ANN ARBOR BUILDING BOARD OF APPEALS

STAFF REPORT

Type of Request: VARIANCE

Building Board of Appeals Request **BBA18-002** at 3380 Nixon Road, Ann Arbor, MI 48104.

SECOND FLOOR PLANS
A102
1612-05

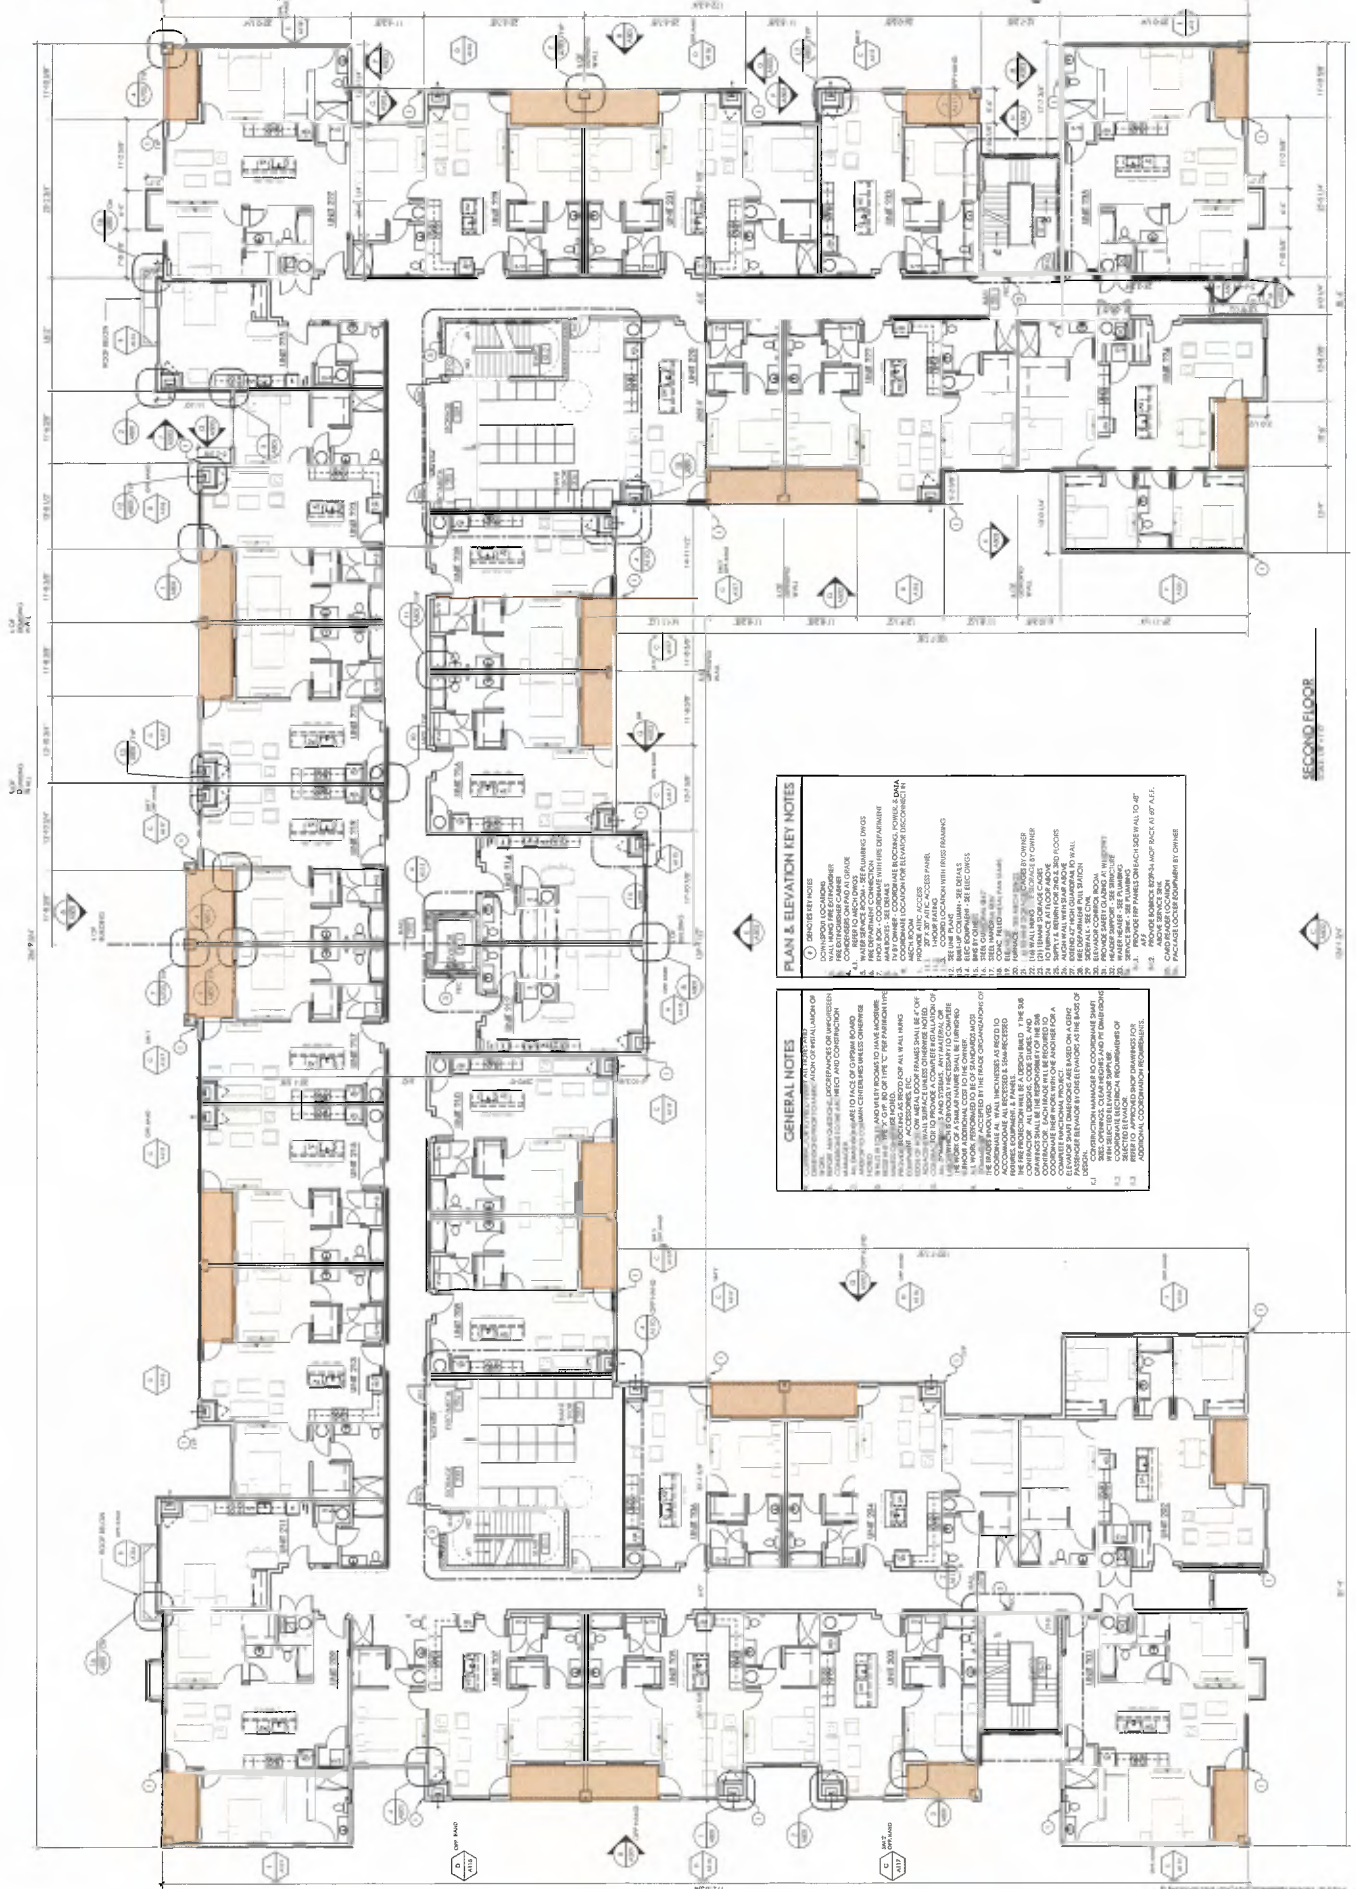
Exhibit A – An overall floor plan of the building with a typical balcony location highlighted.

1. Please note and verify that the fire suppression system will be an NFPA 13, not a 13R system, throughout the building.
 2. The continuity of the one hour fire rated construction elements must continue through each unit to the edge of the exterior, including across and over / under each balcony area (MBC 420.2; 420.3; 708.4 and 711.2.2).

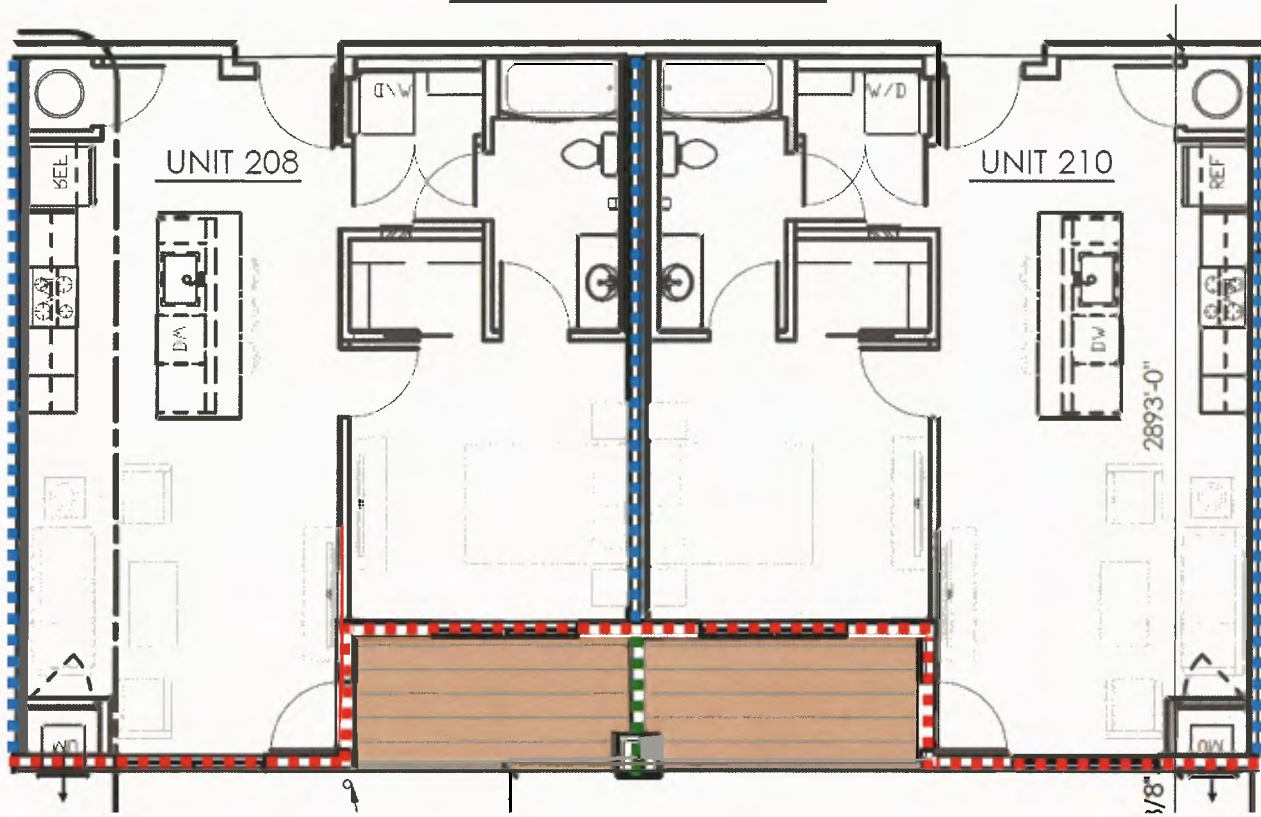
1406.3 Balconies and similar projections. Balconies and similar projections of combustible construction other than fire-retardant-treated wood shall be fire-resistance rated where required by Table 601 for floor construction or shall be of Type IV construction in accordance with Section 602.4. The aggregate length of the projections shall not exceed 50 percent of the building's perimeter on each floor.

3. Balconies and similar projections on buildings of Type III, IV and V construction shall be permitted to be of Type V construction, and shall not be required to have a fire-resistance rating where sprinkler protection is extended to these areas.

TYPICAL FLOOR PLAN

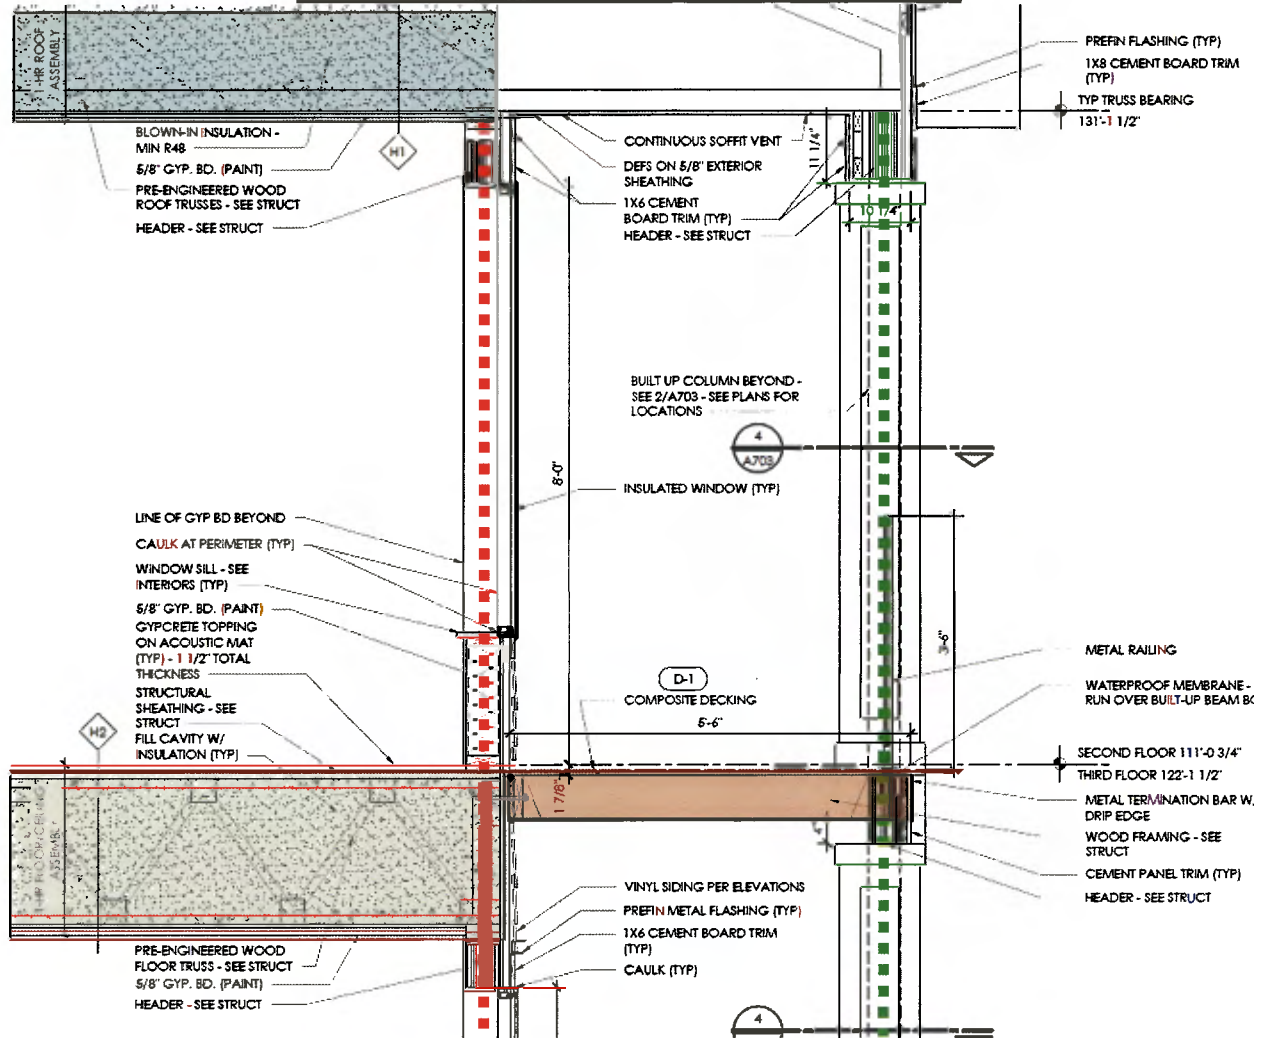
We are appealing an interpretation by the Building Official that results in requiring the exterior balconies to be fire rated construction. The practical hardship is that our interpretation and the response from the International Code Council is that there is an exception that is applicable that we are not able to use that would allow for unrated balconies with the addition of sprinkler protection.
